## PLANNING COMMISSION MEETING

Project Name: Culver's  
 Description: Preliminary site plan approval  
 Date on Agenda this packet pertains to: May 2, 2024

**RE: Culver's- Preliminary Site Plan Review – 2<sup>nd</sup> Review**

RE: Culver’s  
Preliminary Site Plan – Review #2

**CULVER'S**  
 BOGIE LAKE ROAD  
 WHITE LAKE TWP., MI  
 NORTH EAST 1/4 SEC. 20  
 TOWNSHIP 3N, RANGE 8E  
 BOUNDARY & TOPOGRAPHIC SURVEY PLAN

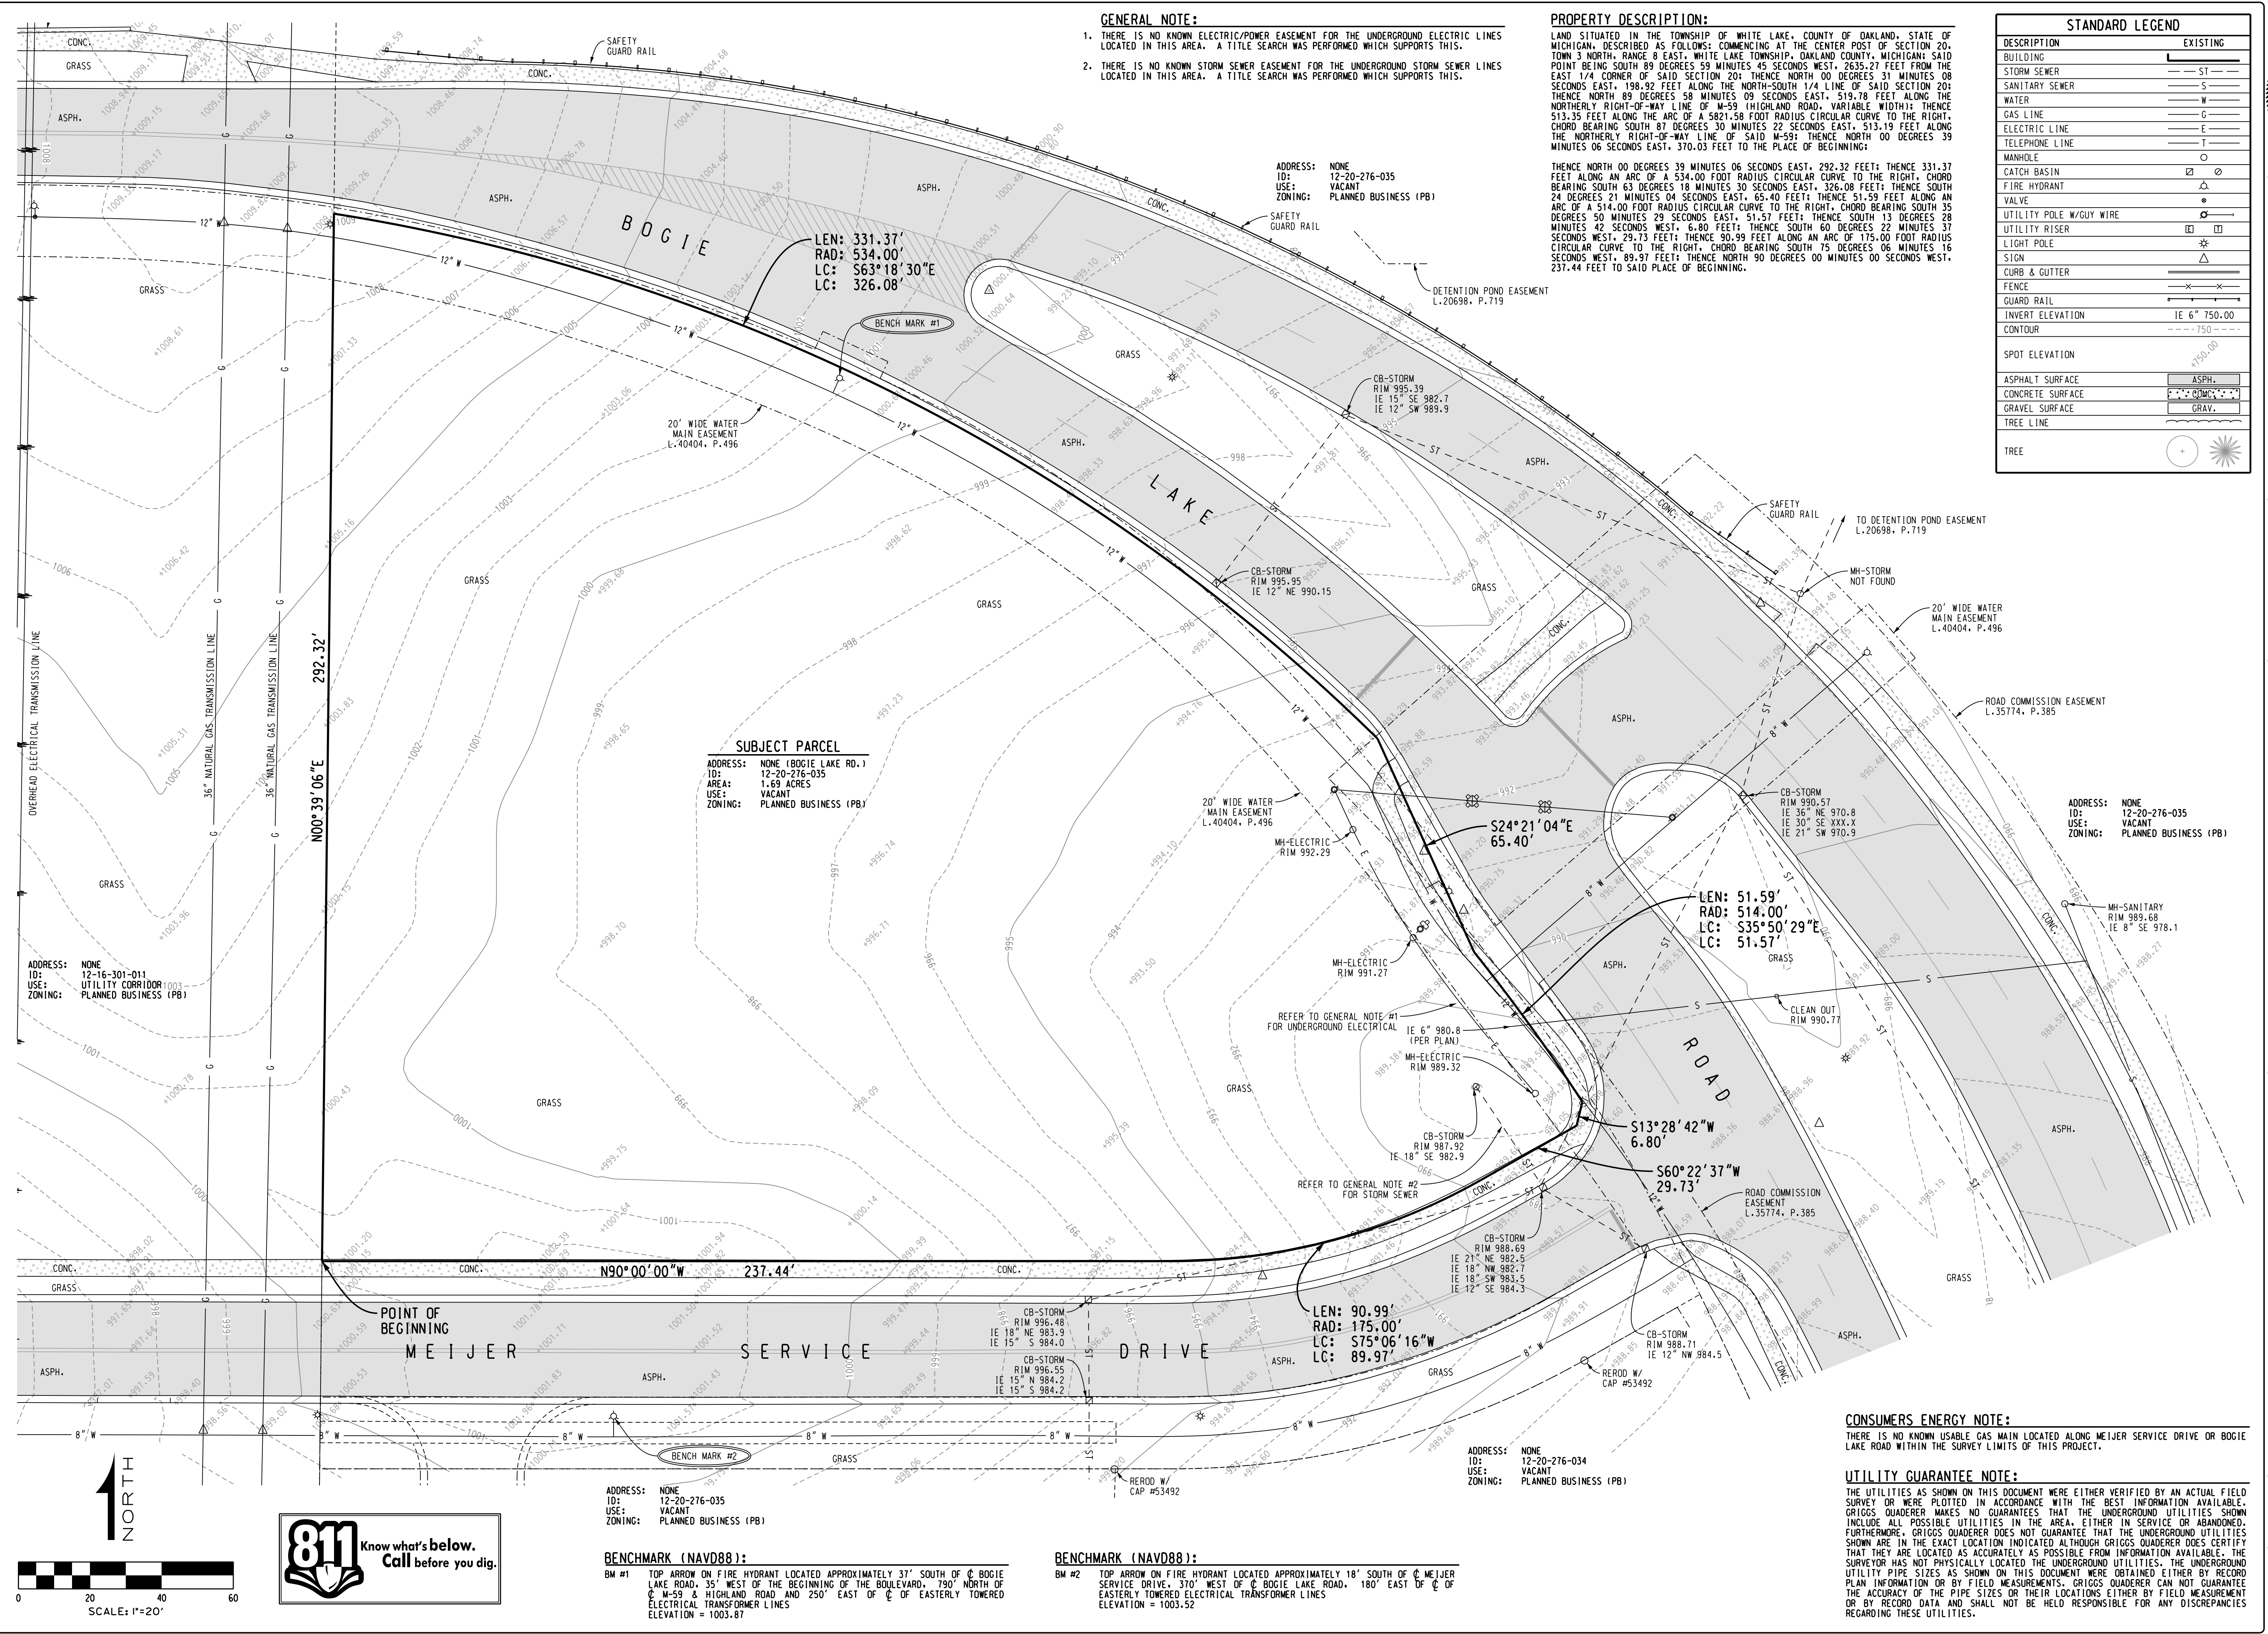
- b) *Sheet C100- Show existing watermain easement for watermain along Bogie Lake Road frontage. In addition, any work within the existing easement shall require permission from the Township. **Comment addressed and remains as a notation regarding permission for work within the existing easement. The 20' wide recorded watermain easement along Bogie Lake Road has now been shown.***

- c) *Sheet C100- Indicate whether there is an existing easement for the existing on site electric/power line. If so, permission from DTE shall be required for work within this easement. **Comment addressed. Per the design engineer, no DTE easement was found during the title search.***

- d) *Sheet C100- Indicate whether there is an existing easement for the existing on site storm sewer (EX1 to EX2). **Comment addressed. Per the design engineer, no easement for storm sewer was found during title search. This portion of the existing storm sewer shall require an easement since it is outside of the existing ROW.***

- e) *Sheet C100- Storm MH EX1- Verify rim and invert elevations. Per attached Meijer storm sewer as built plan, rim and invert as built elevations shown on the Culver's survey differ by approximately 2-3 feet. **Comment addressed; grades were confirmed by surveyor.***

- f) *Sheet C100- Storm MH EX2- The following pipe sizes appear in error based on attached Meijer storm sewer as built plan a) 24" should be 21" diameter b) 15" should be 18" diameter. **Comment addressed. Pipe sizes have been revised.***

- g) *Sheet C100- It appears that the existing storm sewer in Bogie Lake Road to the east is also mislabeled in terms of pipe diameter. Meijer as built plan shows 21" and 36" diameters respectively. Please verify. **Comment addressed. Pipe sizes have been revised.***

- h) *Sheet C100-Benchmark #2 elevation (1003.52) shown appears to deviate by approximately 1.05' versus the identical benchmark (1004.57') provided on the survey(attached) for the adjacent (proposed Panera Bread) property to the southwest. Please clarify. **Comment addressed; grades were confirmed by surveyor.***

- i) *Sheet C100- The following three distances in the Property Description are missing from the property metes and bounds sketch: a) Second paragraph- Line 1-331.37'; b) Second paragraph-Line 4-51.59'; c) Second paragraph-Line 8-90.99'. **Comment addressed. Lengths of curves have now been added to the property metes and bounds sketch.***

**SITE LAYOUT PLAN**

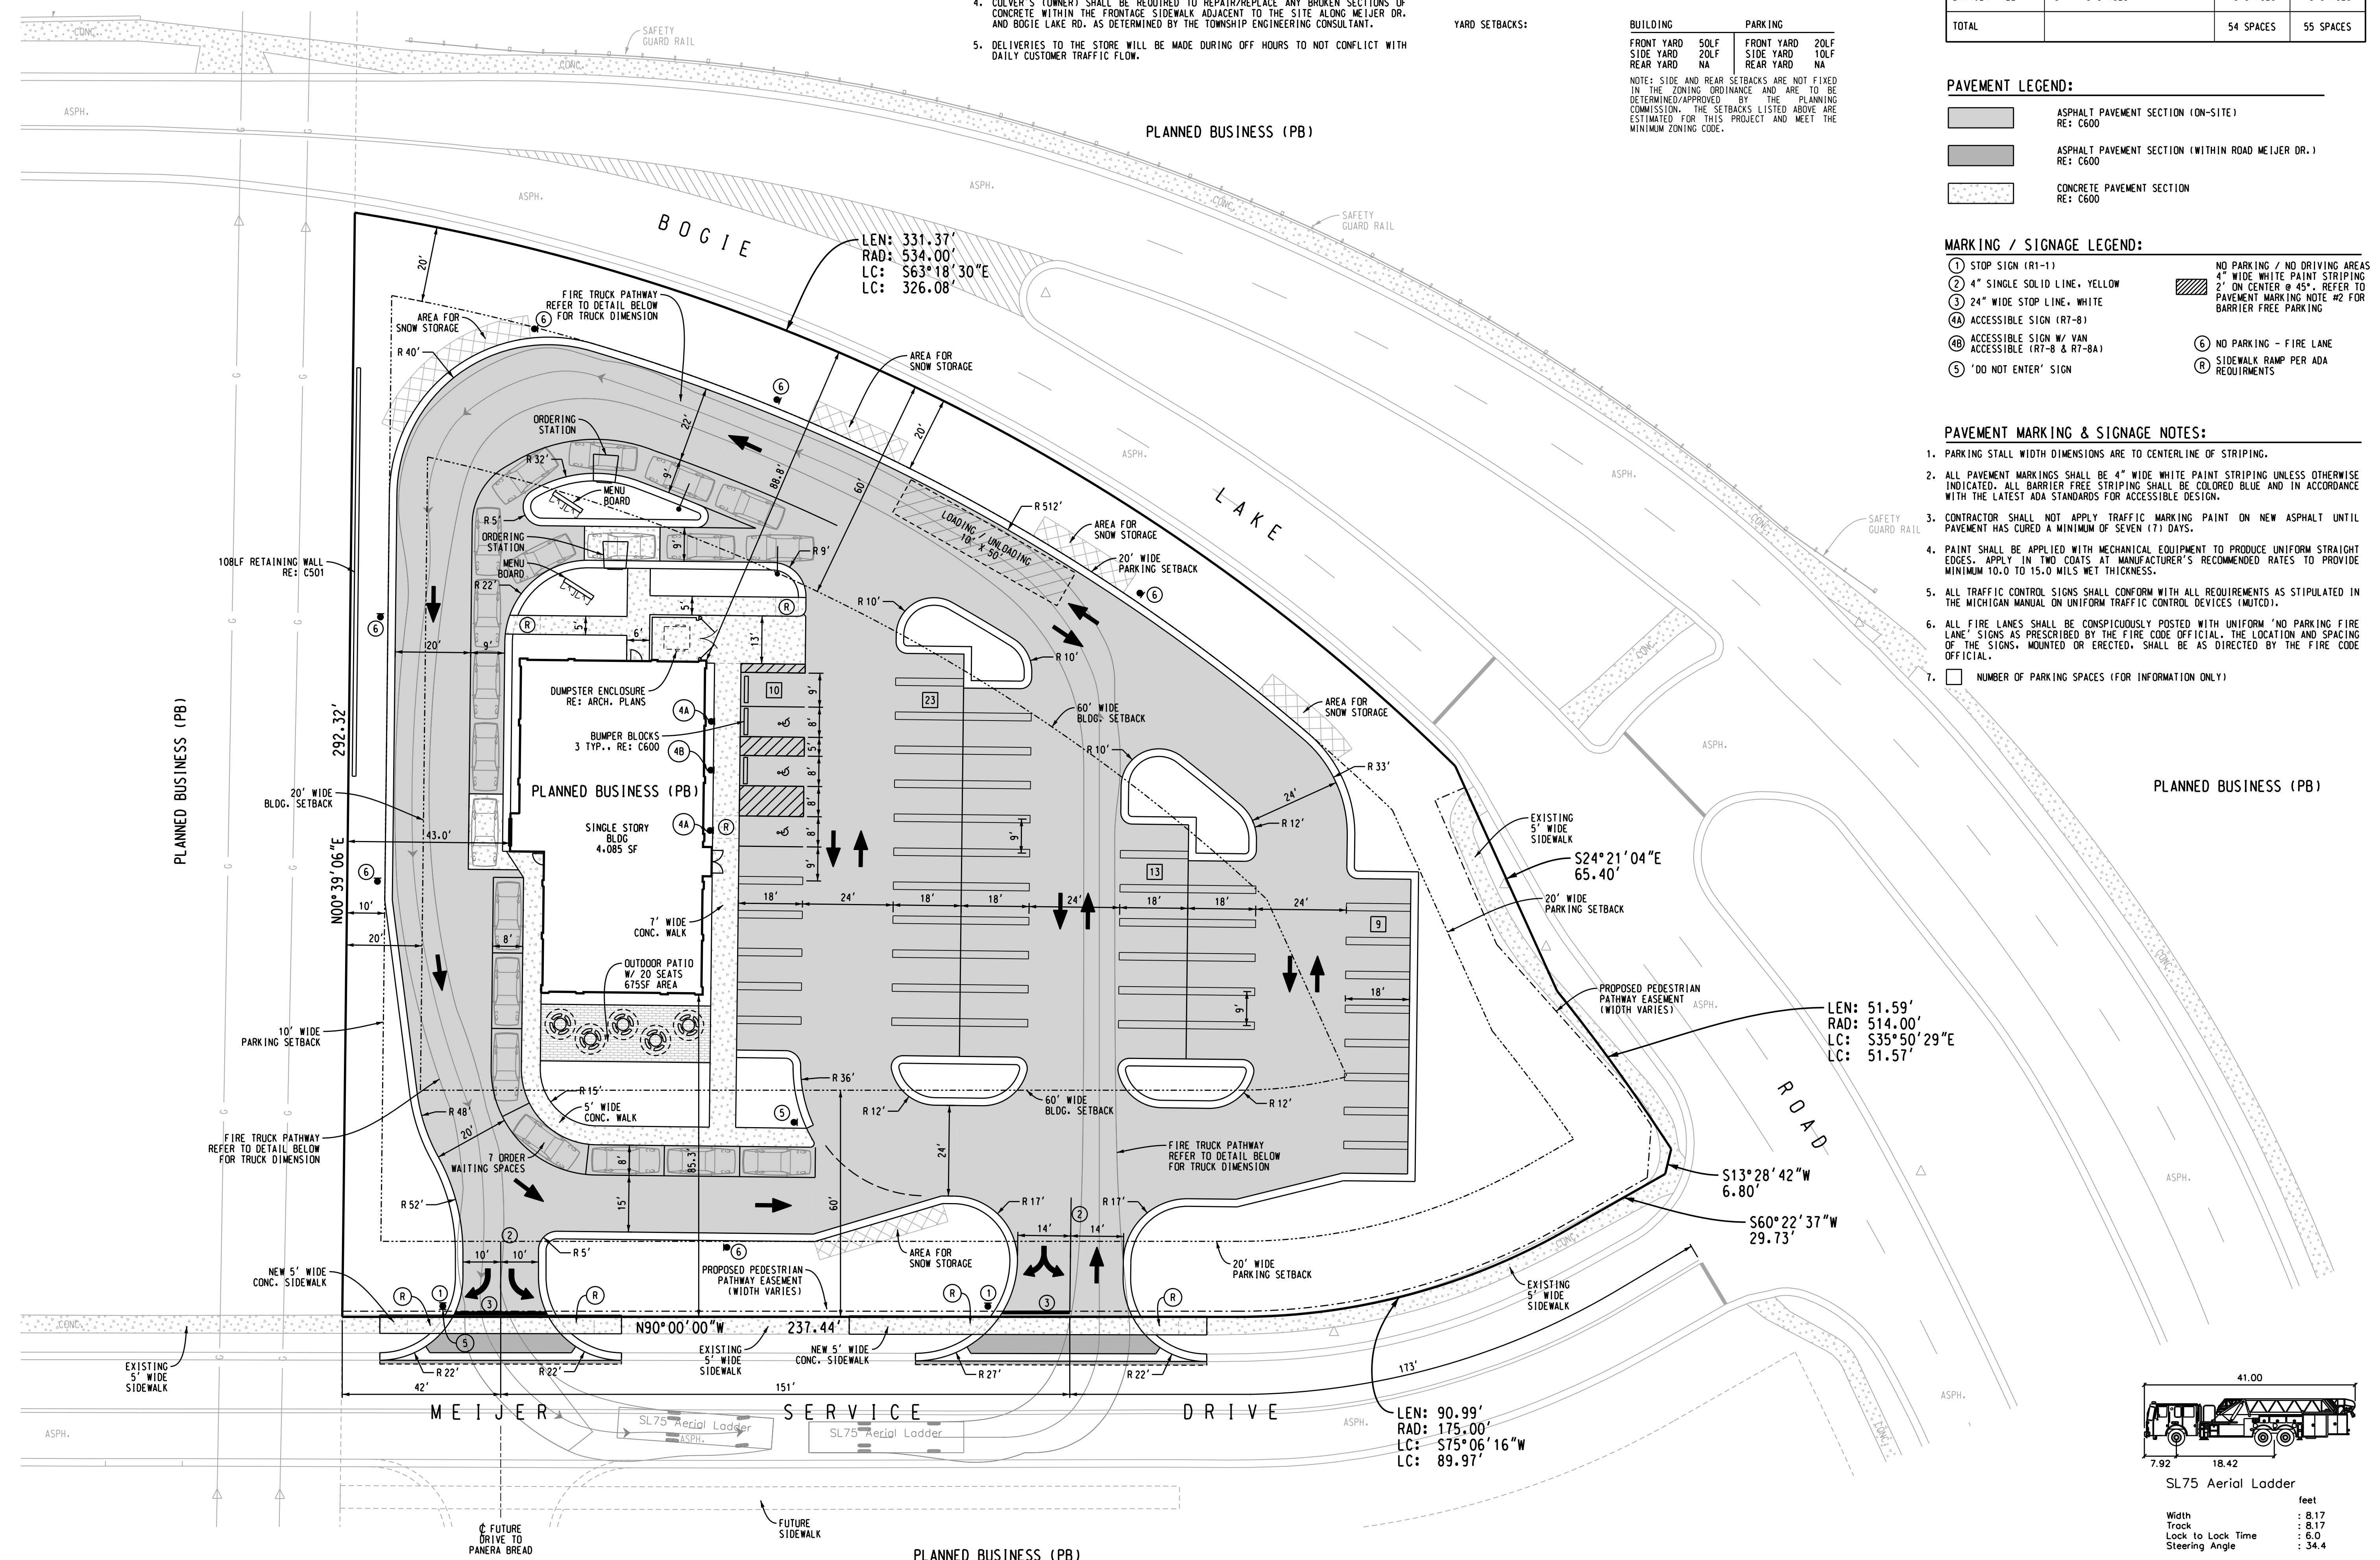
- j) *Sheet C200- It is not clear why bumper blocks are being proposed where the ADA parking + one regular parking space abut the proposed sidewalk. Although the sidewalk abutting the spaces with bumper blocks will not be raised, the sidewalk to the south at a point would still need a sloped sidewalk/ramp up to allow ADA customers access to the restaurant door since the southern portion of this sidewalk does indicate a 6" raised sidewalk. Please review. **Comment addressed and remains as a notation. The design engineer notes the sidewalk adjacent to the bumper blocks shall be flush with the pavement area, with a ramp up to the main entrance proposed. Details for ramp up to main entrance along with proposed grades (meeting ADA requirements) shall be provided on the FSP/FEP.***

- k) *Sheet C200-The 15' wide one way driveway on the south side of the restaurant does not meet the Township minimum 20' width requirement for one way drives. We defer to the Township Planning*

*Department regarding this item. Comment addressed and remains as a notation. Per the design engineer, Culver's shall be requesting a variance for the reduced drive width. We continue to defer to the Township regarding this item.*

- l) *Sheet C200- Clarify the sidewalk easement intent for the existing sidewalks along the Meijer Service Drive and Bogie Lake Road. Is the easement proposed or existing? In addition, we defer to the Township Planning Department as to whether the existing sidewalk along Bogie Lake Road shall be required to be extended to the northwest along the Bogie Lake Road frontage per Township Zoning Ordinance requirements. Comment addressed and remains as a notation. A portion of the existing sidewalk is within the Culver's property and the design engineer has stated the intent to grant pedestrian access along the existing sidewalk to allow for continued use. We continue to note the requirement for a sidewalk easement for the portion of sidewalk on the Culver's property that is outside the Bogie Lake Road ROW. We continue to defer to the Township as to whether the existing sidewalk along Bogie Lake Road shall be required to be extended to the northwest along the Bogie Lake Road frontage.*

An outdoor patio with 20 seats (five tables) is proposed on the south side of the building. **Label the size (square footage) of the patio on Sheet C200. (Comment addressed. A note has been added to Sheet C200 indicating the patio is 675 square feet in size).**
